Addendum 128 – UN Regulation No. 129

Revision 1 - Amendment 7

Supplement 6 to the 01 series of amendments – Date of entry into force: 11 January 2020

Uniform provisions concerning the approval of Enhanced Child Restraint Systems used on board of motor vehicles

Minimum label size 40 x 40 mm

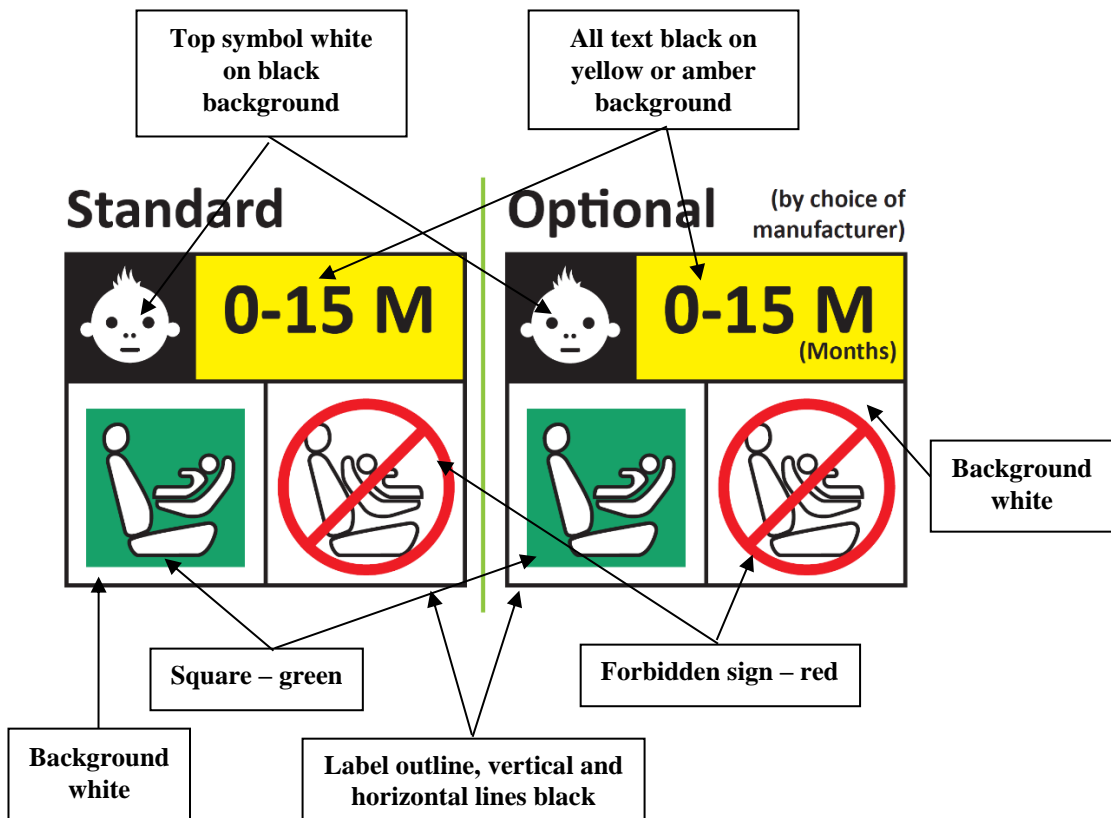
Paragraph 4.5., amend to read:

"4.5. Integral Enhanced Child Restraint Systems that can be used forward and rearward facing, shall have the following label permanently attached on the part hosting the child and visible to the person installing an Enhanced Child Restraint System in the vehicle:

The manufacturer shall be permitted to include the word "months" to explain the symbol "M" in the label. The word "months" should be in a language commonly spoken in the country or countries where the product is sold. More than one language is allowed.

Minimum label size 40 x 40 mm

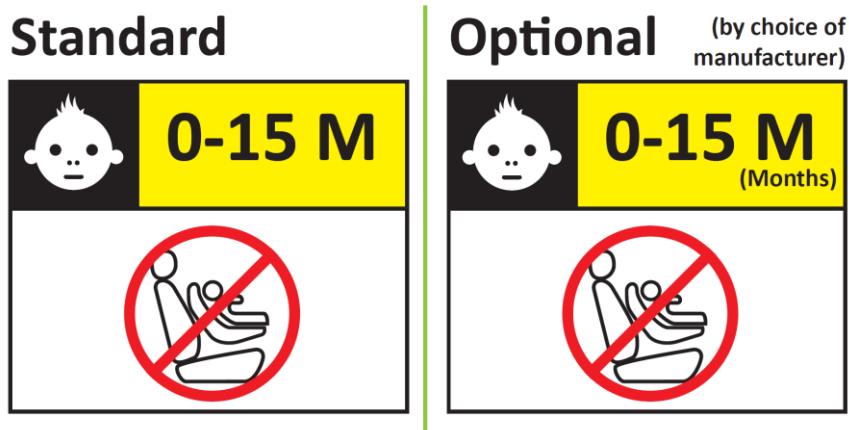
Integral Enhanced Child Restraint Systems that can be used forward facing only shall have the following label permanently attached on the part hosting the child and visible to the person installing an Enhanced Child Restraint System in the vehicle:

The manufacturer shall be permitted to include the word "months" to explain the symbol "M" in the label. The word "months" should be in a language commonly spoken in the country or countries where the product is sold. More than one language is allowed.
